Remarks/Arguments

The specification is amended at paragraph [0012] to better conform to the official translation and to clarify the description of gap 18 as shown in Fig. 1 and its relationship to the plate 34 (Figs. 1 and 2):

Fig. 1

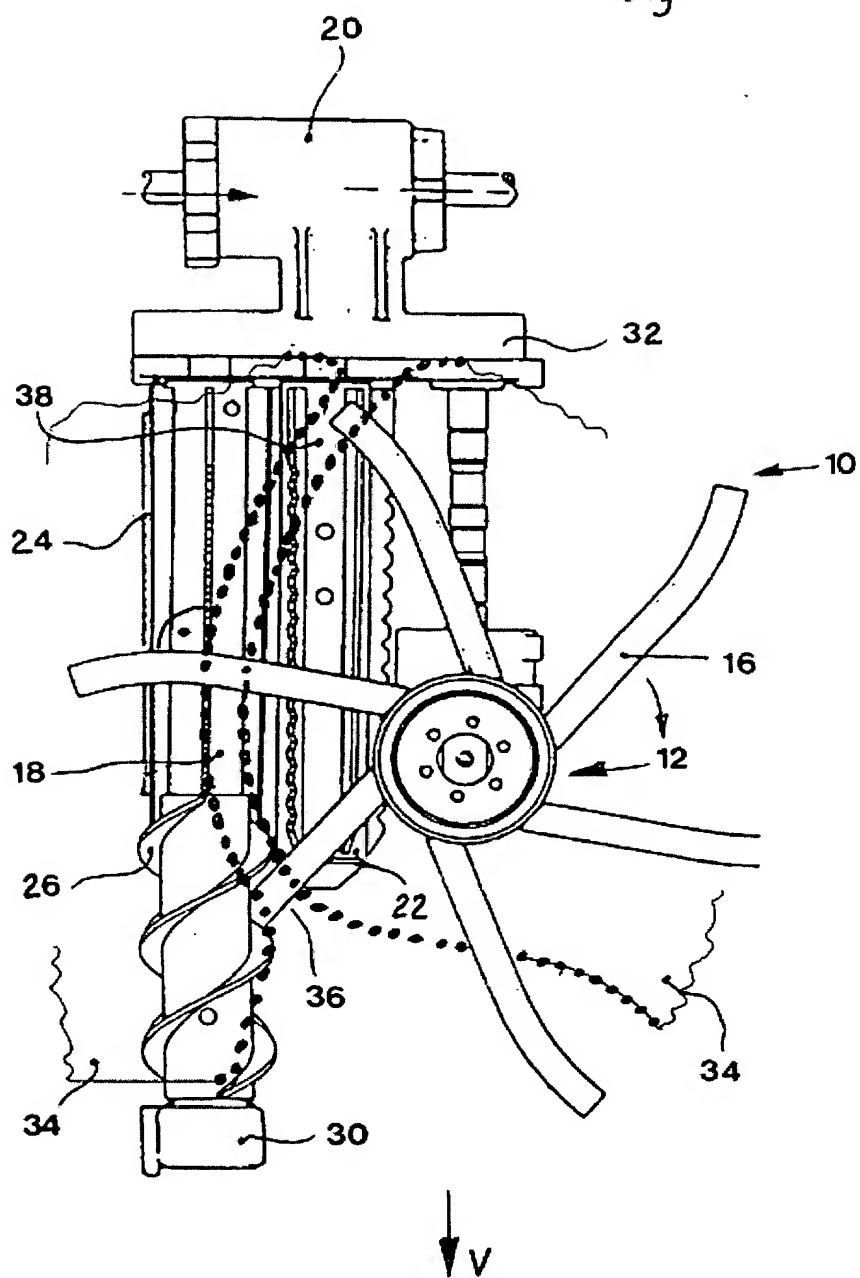
It is stated in the Detailed Action that Figure 1 merely shows dotted lines as defining the picking gap. Although solid and broken lines are not shown in the Figure to indicate open and hidden components, etc., there can be no doubt in the mind of observer that the gap is clearly shown and highlighted by the dotted lines. The picking gap 18 is a curved gap in the plate 34. The portions of the plate 34 on both sides of the gap 18 are shown in Fig. 1, and the location of the plate 34 is shown in Fig. 2.

"The picking gap 18 is ~~defined by~~ provided in an approximately horizontal stripper plate 34 that is arranged beneath the fingers 16 and above the picking rolls 22 and 24."

A new drawing figure is attached to replace the original Figure 1 to add broken lines, etc., to more clearly designate open and hidden components. No new matter has been added since the corrections are supported by specification, claims and original Figures 1 and 2 as filed. Please note the location of the plate 34 in Figure 2 and the descriptions set forth herein above.
